Docket Number:	15-AFC-01
Project Title:	Puente Power Project
TN #:	206533
Document Title:	Applicant's Responses to City of Oxnard Data Requests Set 2, 30-Day Extension (59, 60, and 62)
Description:	N/A
Filer:	Paul Kihm
Organization:	Latham & Watkins LLP
Submitter Role:	Applicant Representative
Submission Date:	11/6/2015 3:51:42 PM
Docketed Date:	11/6/2015

Puente Power Project (P3)
Oxnard, CA

**Responses to City of Oxnard
Data Requests Set 2
30-Day Extension (59, 60 and 62)**

FIGURE 59-2

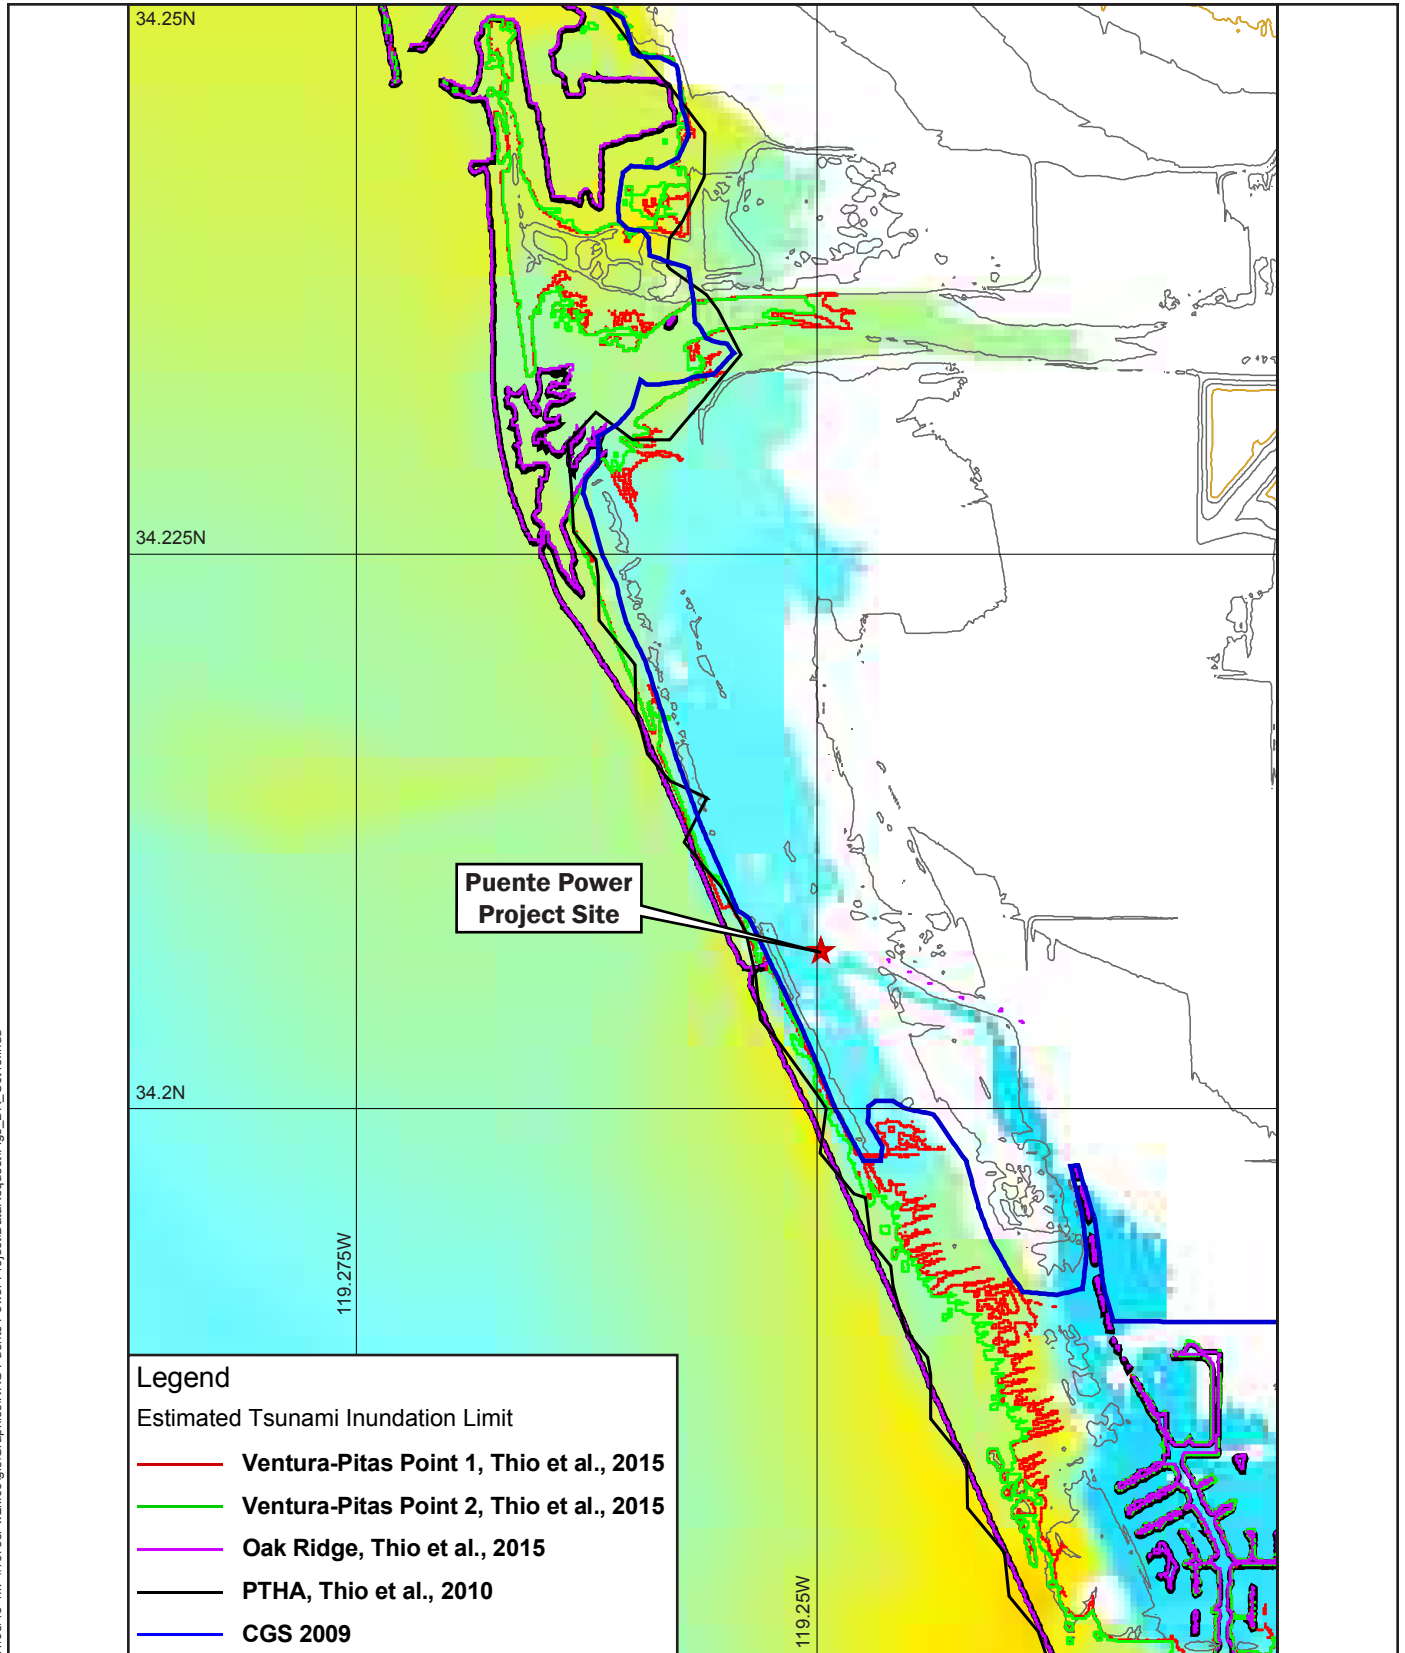
59. Please prepare a tsunami runup hazard analysis that includes the most recent information on the Ventura Fault and Southern California fault system and propose mitigation for any impacts. Your analysis should include an updated tsunami hazard map that includes all recently discovered faults.

Probabilistic Results: Several probabilistic tsunami hazard analyses have included the project site area. Thio et al. (2010) carried out a probabilistic analysis of the tsunami hazard in California. This analysis was based on distant large earthquake sources around the Pacific Rim. The analysis produced inundation maps at about 100 feet (30 meters) horizontal resolution for return periods of 72, 475, 975, and 2,500 years. Even for the 2,500-year return period (2 percent probability of exceedance in 50 years or 1.2 percent probability in 30 years), the inundation does not reach the project site in these models. Figure 59-2 presents the hazard curve for this model for an offshore location close to the site (note graph has log-log axes). Figure 59-2 shows that the hazard is small for return periods less than 1,000 years (tsunami wave height of about 6 feet [or 2 meters]), and the hazard increases significantly above an annual return period of about 1,500 years.
